FA Bhatti Industries

Pakistan ACCORD for Health and Safety in the Garment and Textile Industry

Structural Safety Inspection Report

Pakistan Accord Initial Safety Inspection Report

Figure 2.1 - Location of concrete spalling at first floor slab of Building 6

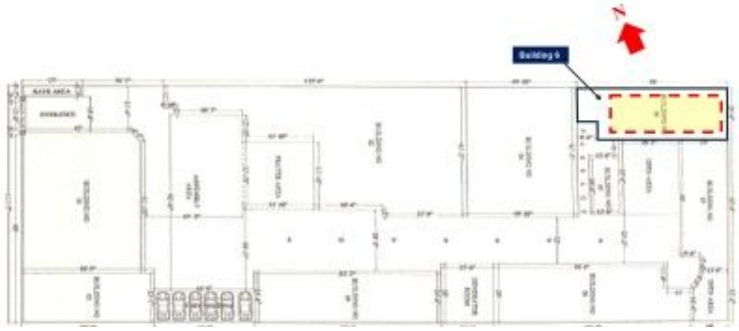
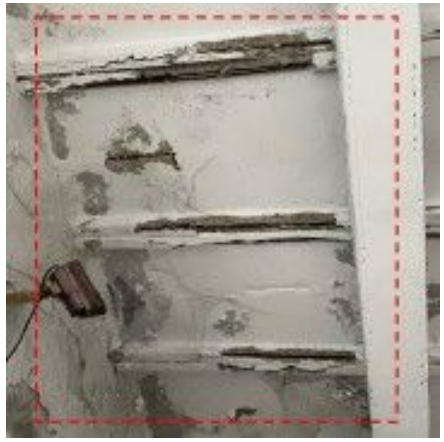
This issue refers to the building 6, where spalling of Concrete was observed at the first-floor slab (Precast Panels).
This is likely due to the moisture ingress and lack of water proofing, which may have caused the corrosion of the reinforcing steel, leading to the spalling of concrete cover.F-202604-064987

Timeline	Remediation Plan
Medium Term CAP-0076920	Identify the cause of the damage and propose measures to prevent further damage.
Medium Term CAP-0076921	Inspect damage to the slab and propose repair to structure.
Medium Term CAP-0078353	Submit report capturing above to Pakistan Accord for approval.
Longer Term CAP-0076922	Implement the required remedial work.
Longer Term CAP-0076923	Continue to Monitor further damage.

Figure 2.4 - Location of Concrete spalling at first floor slab of Building 7

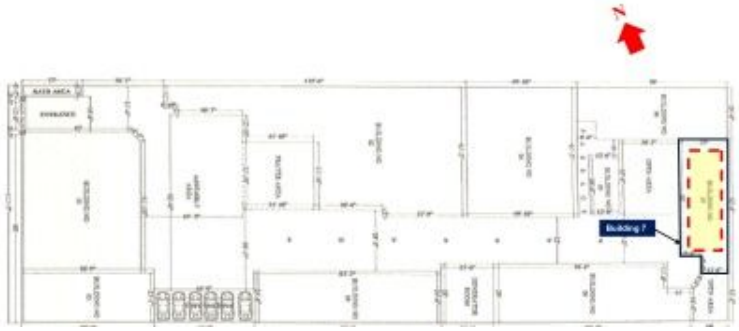
This issue refers to the building 7, where spalling of Concrete was observed at the first-floor slab (Precast Panels).
This is likely due to the moisture ingress and lack of water proofing, which may have caused the corrosion of the reinforcing steel, leading to the spalling of concrete cover.F-202604-064988

Timeline	Remediation Plan
Medium Term CAP-0076924	Identify the cause of the damage and propose measures to prevent further damage.
Medium Term CAP-0076925	Inspect damage to the slab and propose repairs to structure.
Medium Term CAP-0078354	Submit report capturing above to Pakistan Accord for approval.
Longer Term CAP-0076926	Implement the required remedial work.
Longer Term CAP-0076927	Continue to Monitor further damage.

Figure 2.9 - Location of Missing edge protection at roof of Building 6

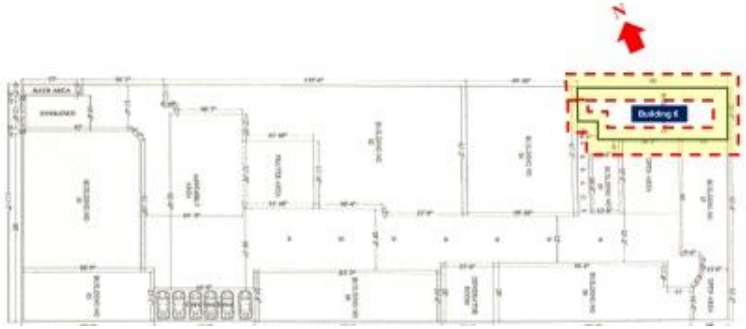
This refers to Building 6.
Edge protection is not provided on the roof level of Building 6. Although the roof was inaccessible, the air-conditioning outdoor unit was found on the roof. Missing edge protection presents a risk of potential injury resulting from slip, trip or fall from the roof while accessing and maintaining services on the roof. This is a Health and Safety Concern.F-202604-064990

Timeline	Remediation Plan
Immediate CAP-0076929	Provide adequate edge protection and safe access on the roof, and on any other part of the factory with the same issue.

Figure 2.11 - Location of Missing edge protection at roof of Building 7

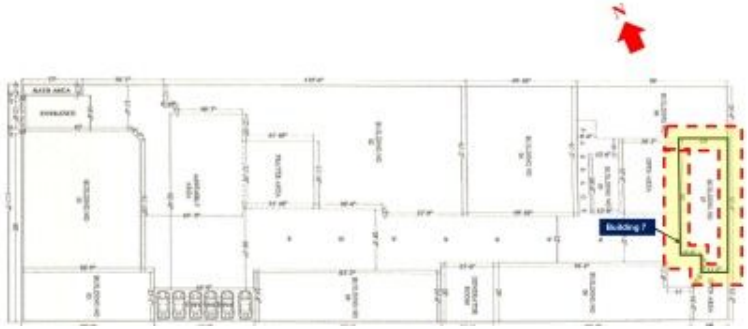
This refers to Building 7.
Edge protection is not provided on the roof level of Building 7. Although, the roof was inaccessible, water tank was witnessed. Missing edge protection presents a risk of potential injury resulting from slip, trip or fall from the roof while accessing and maintaining services on the roof. This is a Health and Safety Concern.F-202604-064991

Timeline	Remediation Plan
Immediate CAP-0076930	Provide adequate edge protection and safe access on the roof, and on any other part of the factory with the same issue.

Figure 2.13 - Location of Missing Edge Protection at roof of Building 8

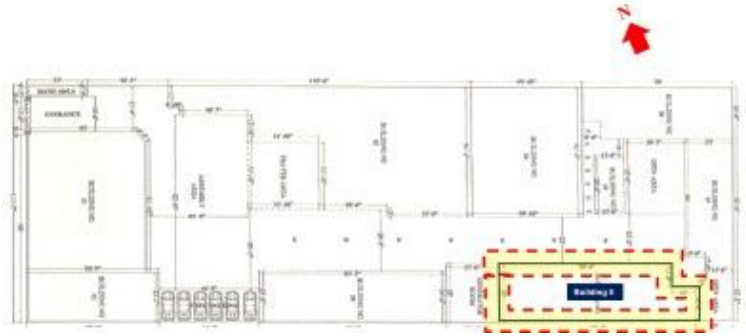
This refers to the Building 8.
Edge protection is not provided on the roof level of Building 8. Furthermore, the internal staircase of Building 8 is also missing an edge protection/safety handrail. Missing edge protection presents a risk of potential injury resulting from slip, trip of fall from the stairs or roof, while accessing and maintaining services on the roof. This is a Health and Safety Concern.F-202604-064992

Timeline	Remediation Plan
Immediate CAP-0076931	Provide adequate edge protection on the roof, and on any other part of the factory with the same issue.
